Re: Lot 58– Oxbow Bluff; 3rd and Final Review for Lot Specific Grading and Drainage Plan

LOT 58-P1 OXBOW	DRAWN BY JDG
	GRADING AND DRAINAGE PLAN	DATE 11-05-2016
	11/14/16 11/7/16	SHEET # 1 OF 1
	DAVID SOULE P.E. #14522	JOB #

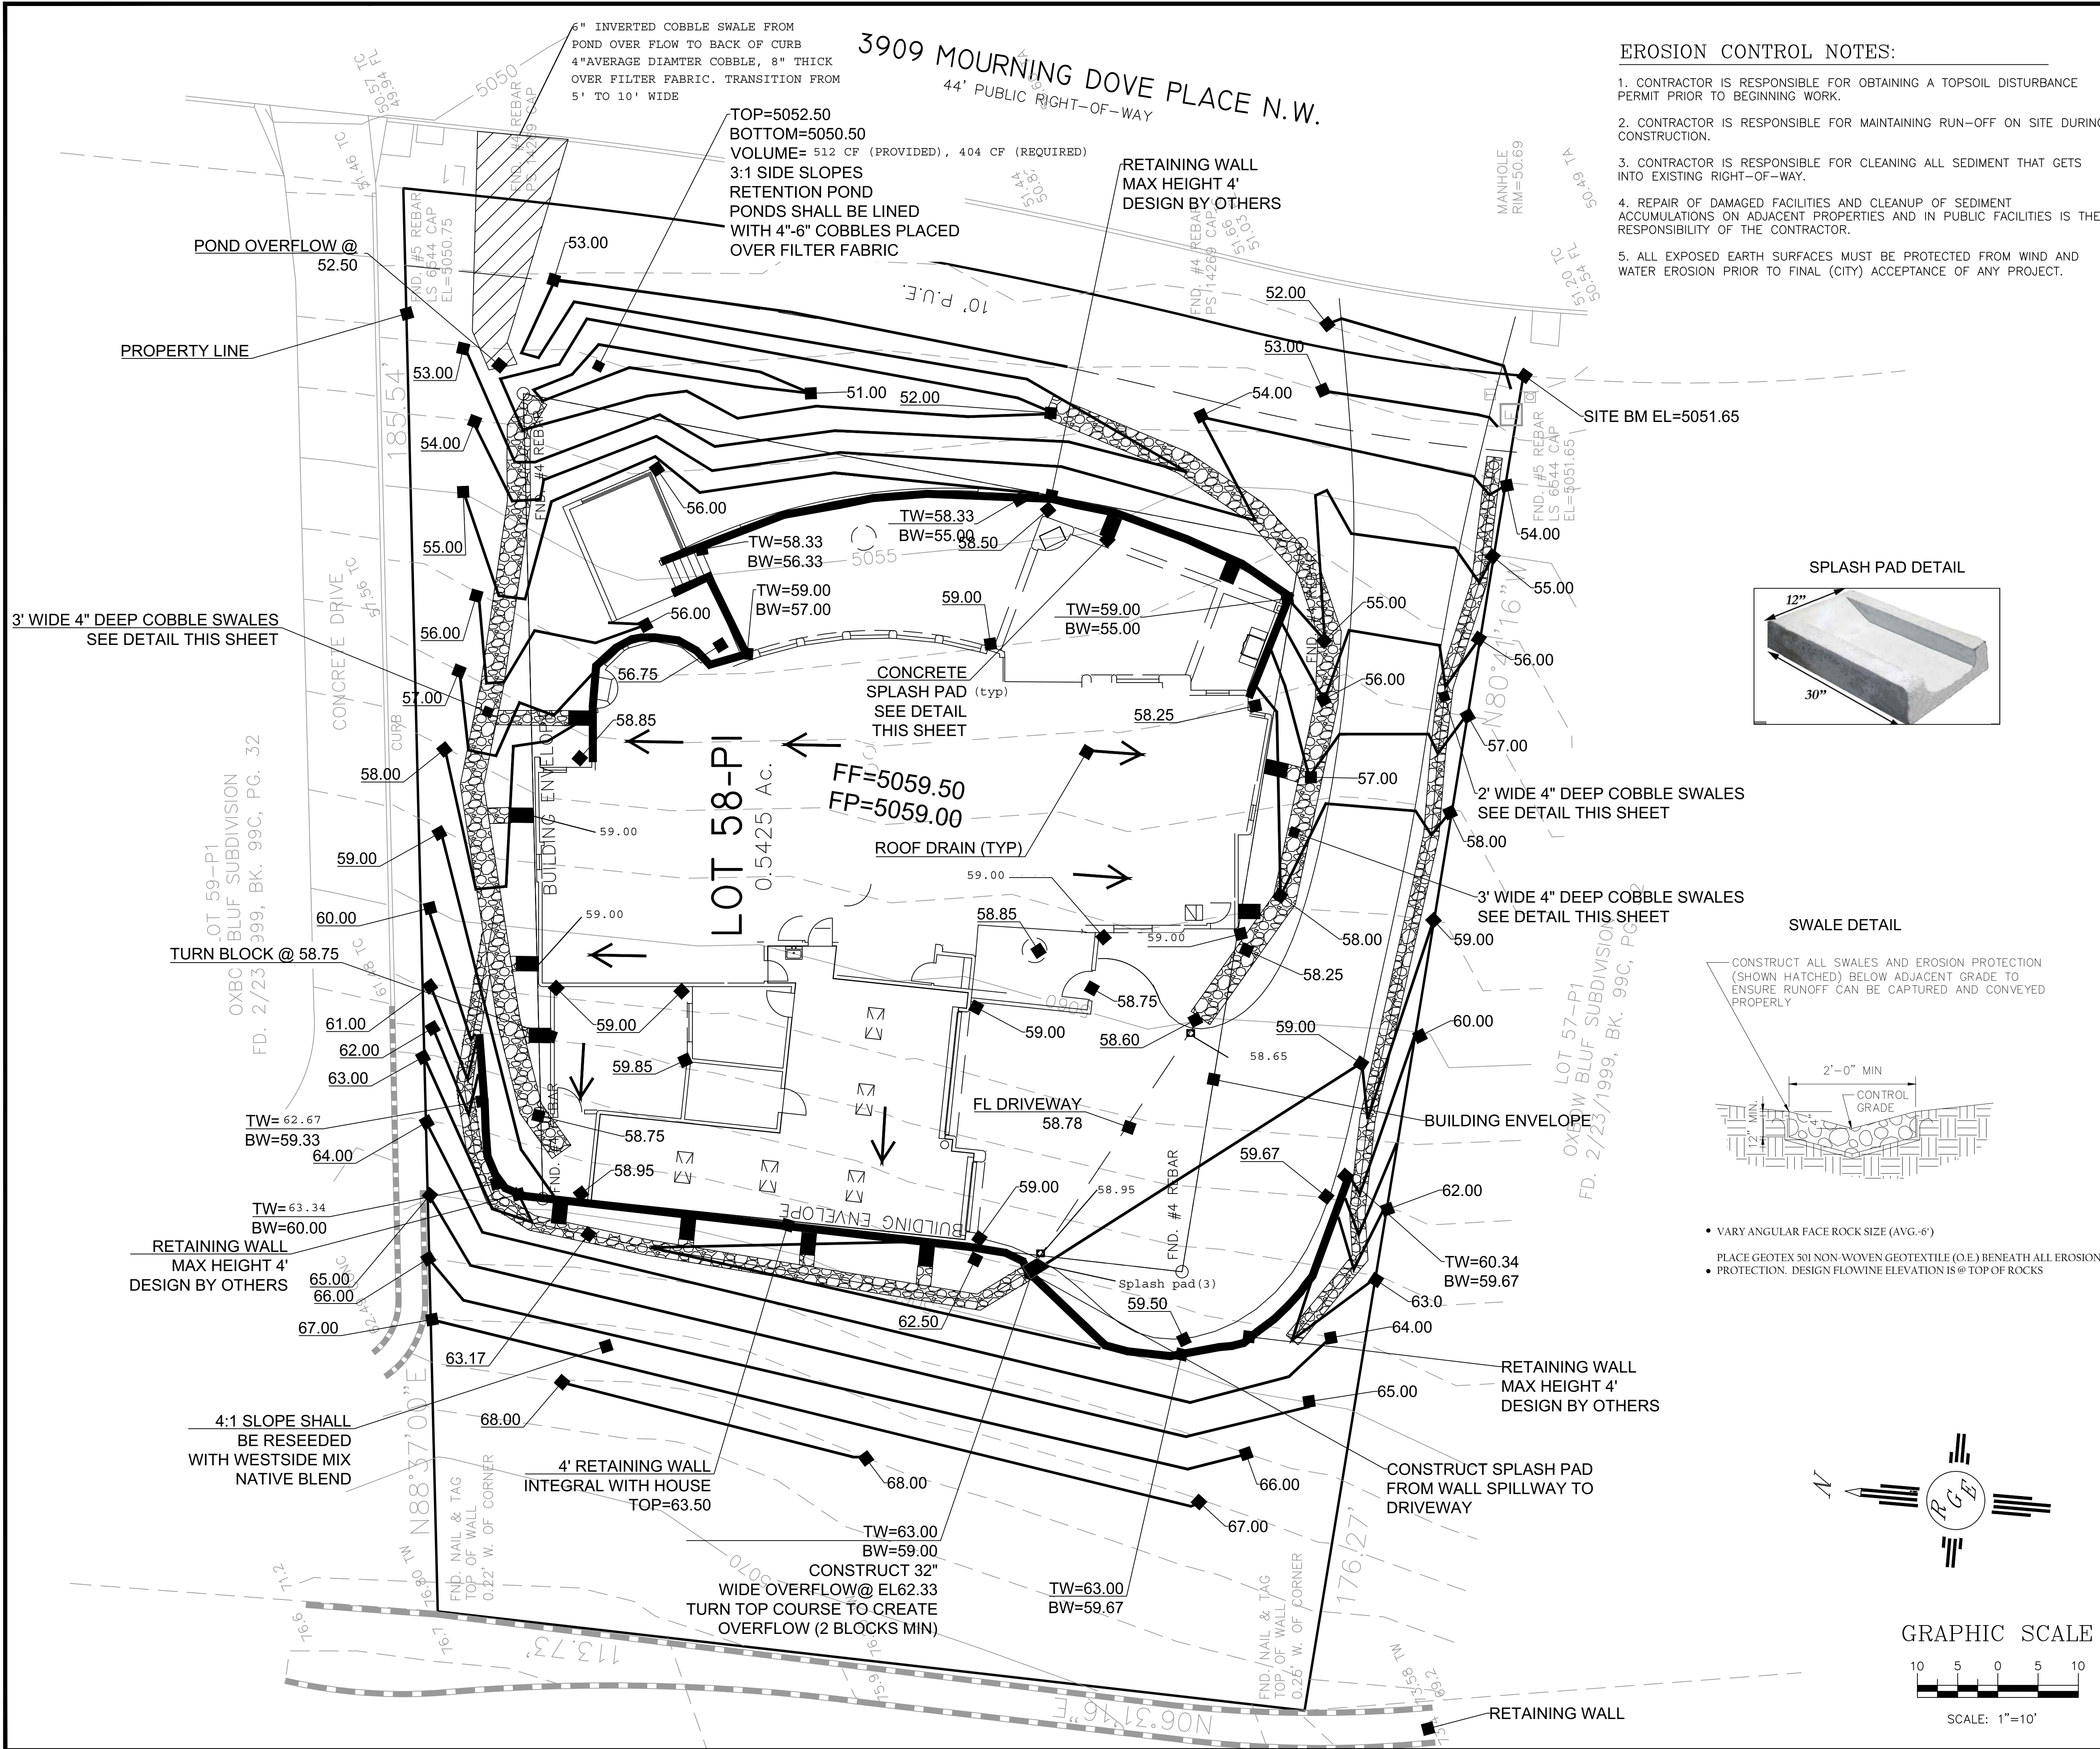
Based on the revised grading and drainage plan for the above referenced Lot stamped dated 11/14/16 by David Soule, Rio Grande Engineering, it appears that all the comments have been addressed in regards to the grading and drainage.
